# Technical Note on Layout

Phase 1C, Northern Arc,  
Burgess Hill

## Appendix A

## WEST SUSSEX COUNTY COUNCIL CONSULTATION

Drawing Number: 12824\_2200 Rev: P7

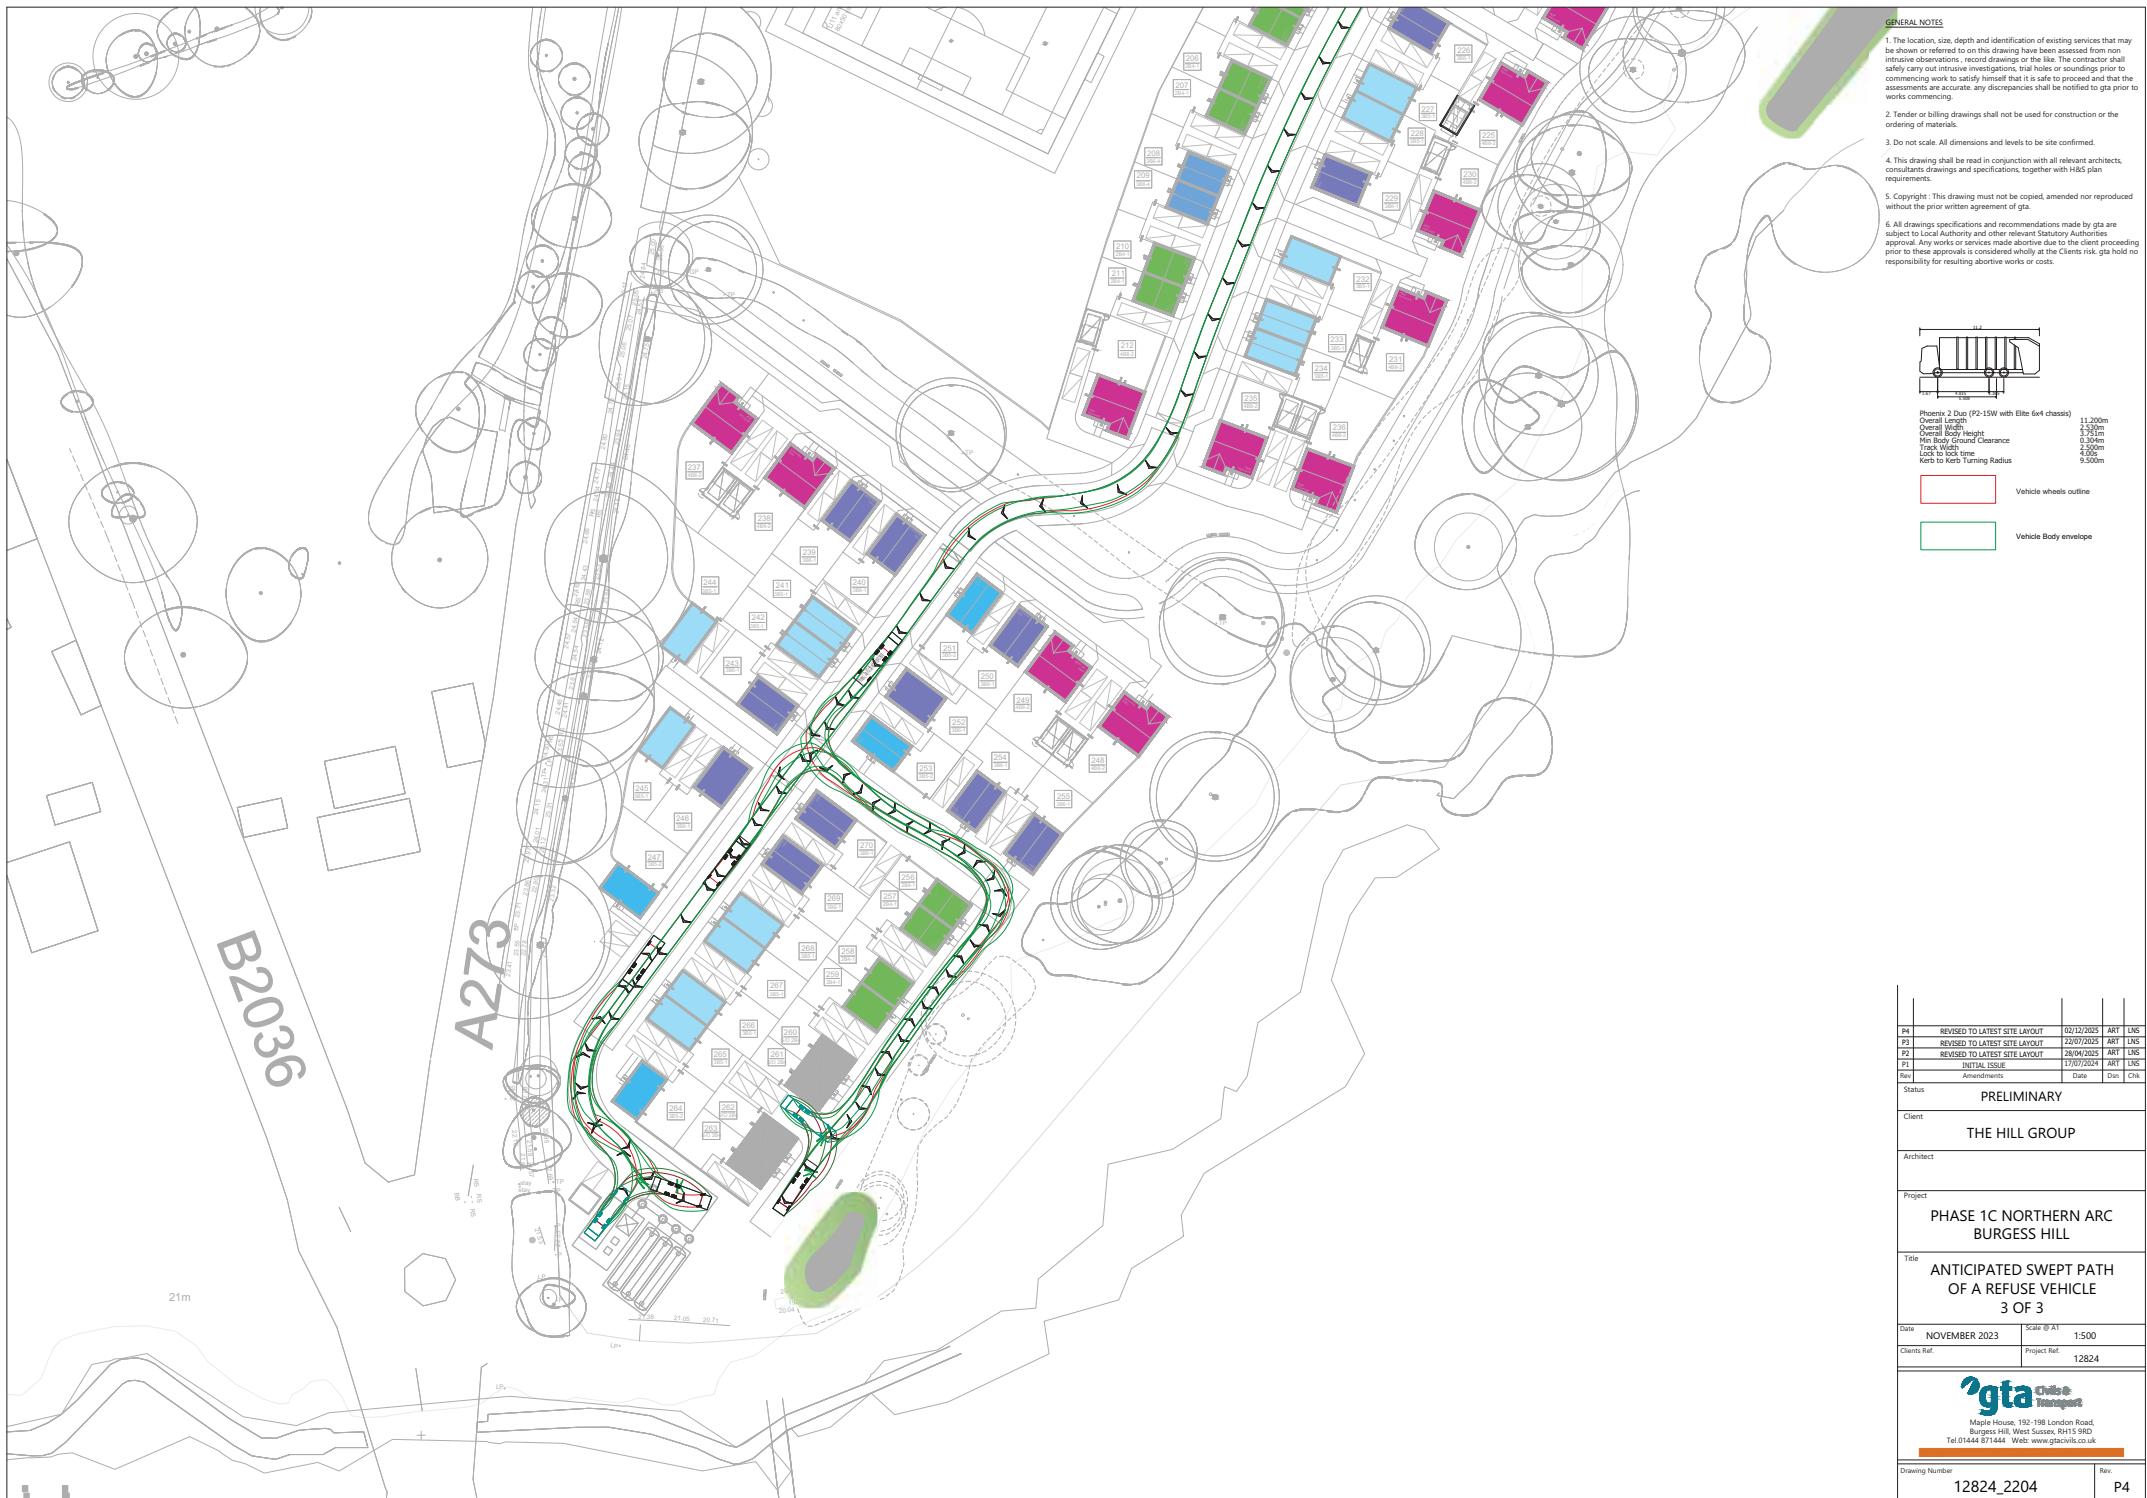
2. *WSCC comment: "The south eastern tracking for a refuse vehicle would appear very tight with little margin for error and requiring vehicles parked exactly within the parking area and a significant overhang of the adjoining footway, whilst the movements would be limited to a weekly collection any opportunity to improve the manoeuvre would be beneficial."*

Refuse Vehicle tracking – The south eastern tracking for a refuse vehicle would appear very tight with little margin for error and requiring vehicles parked exactly within the parking area and a significant overhang of the adjoining footway, whilst the movements would be limited to a weekly collection any opportunity to improve the manoeuvre would be beneficial.

Designer's Response: This area has been amended to allow for easier refuse vehicle turning movement. This has been provided by localised widening of the road. Please see updated refuse vehicle swept path analysis contained in **Appendix C**.
